Service Bulletin

JULY

NO. 339

Studebaker and Packard

Fig. 1

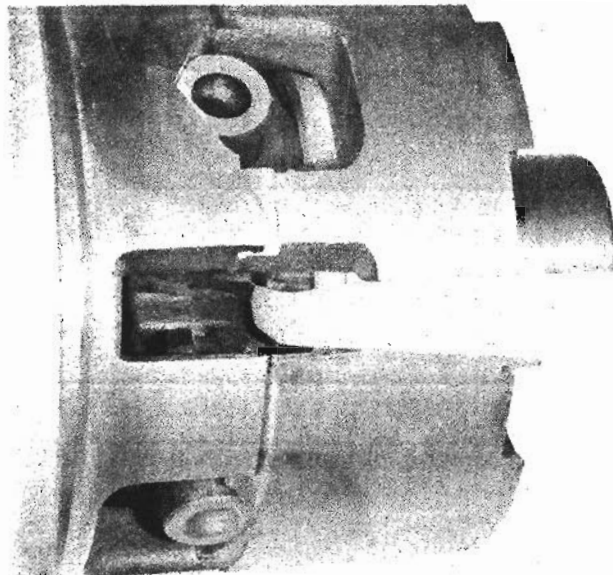
1. Drain the rear axle differential case.
2. Remove the differential case cover.
3. Using a modified hacksaw blade as shown in Figs. 1, 2 and 3, insert the hacksaw blade between the pinion mate shaft and the differential side gear. The hacksaw blade should be

positioned so that it bears against the thrust pin with the saw teeth forward.

4. Pressure should be maintained against the hacksaw blade and thrust pin while the rear axle shaft is removed. The hacksaw blade should be placed between the pinion mate shaft and right hand differential side gear while removing the right side axle shaft and between the pinion mate shaft and left hand differential side gear while removing the left side axle shaft.

Fig. 4

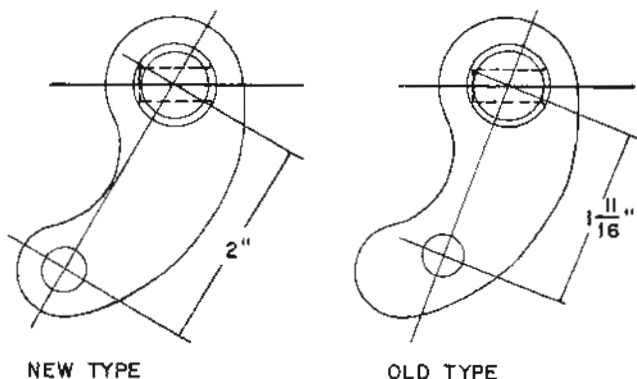
Under certain circumstances it is possible some gear clashing may occur even though the clutch pedal free travel is properly adjusted. Where this condition occurs it is recommended that Clutch Operating Shaft and Lever Assembly, Part No. 1546329, be installed.

This shaft and lever assembly has a lever radius of 2" instead of 1 11/16" radius originally installed and provides a greater release area for the clutch driven plate (See Fig. 4)

Effective with Serial No. G-1428648 the clutch operating shaft and lever assembly with the 2" lever radius entered production.
